1 2 3 ALTERATION NUMBER FOR SUBJECT APPLICATION

PL2	IS1302	ED	-	FK	ISSUED FOR PLANNING ALTERATIONS
Rev	Date	By	Chk	App	Revision
Drawing Title					
PLANNING ALTERATIONS					
Job Title					
INDUSTRIAL DEVELOPMENT AT TAY LANE, GREENOGUE RATHCOOLE, Co. DUBLIN					
Drawing Title					
DRAINAGE & WATERMAIN LAYOUT					
Architect/Client					
ELECTRICAL WASTE MANAGEMENT LTD					
KAVANAGH BURKE CONSULTING ENGINEERS					
Tel. 01-450 0694		Unit F3, Calmount Plk.		Ballymount, Dublin 12.	
Fax. 01-426 4340		Email: pkavanagh@kavanaghburke.ie			
Drn	ED	Checked	-	Approved	FK
Scale	1:500	Date	October 2021		
Job No.	D1541	Drawing No.	D3	Rev.	PL2

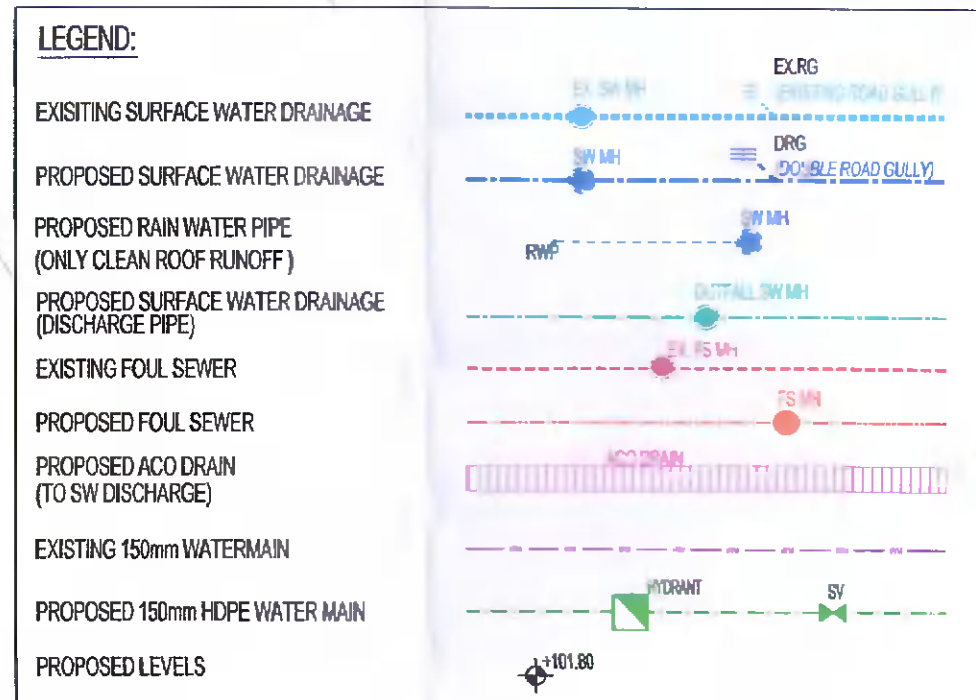
F. Associated drainage adjustments due to the inclusion of the alterations above plus reduction of surface water and foul sewer outfall route as per as built access road and services which serve built developments to the east of the site.
